Access Compliance Report Public Rights-of-Way (Curb Ramps)

Main Street: CHIQUITA_CANYON_DR		Cross Street: AIROSO_ST		Location:	N
ADA ID: RPRK211124131128	Ramp Type:Type 1 - Perpendicular	Initial Pass/Fail: Fail	Overall Compliance: No	Severity Score:	2
Codes/Mitigation Info/Possible Solution			Field Measurements/Component Compliance

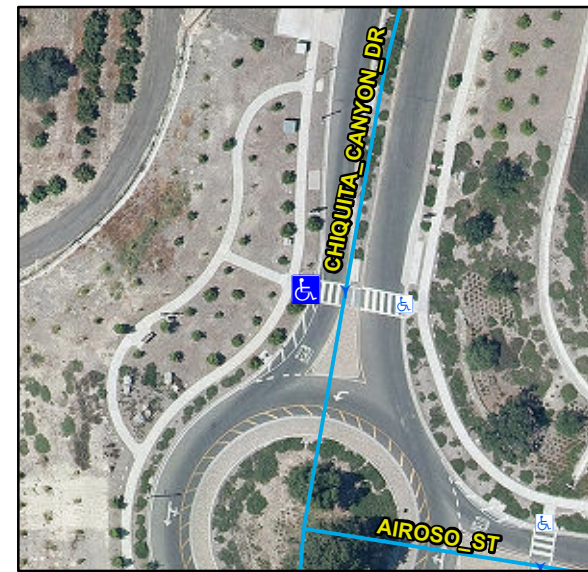
R304.2.2, R304.5.3, STD 1115

Remove & Replace Entire Ramp.
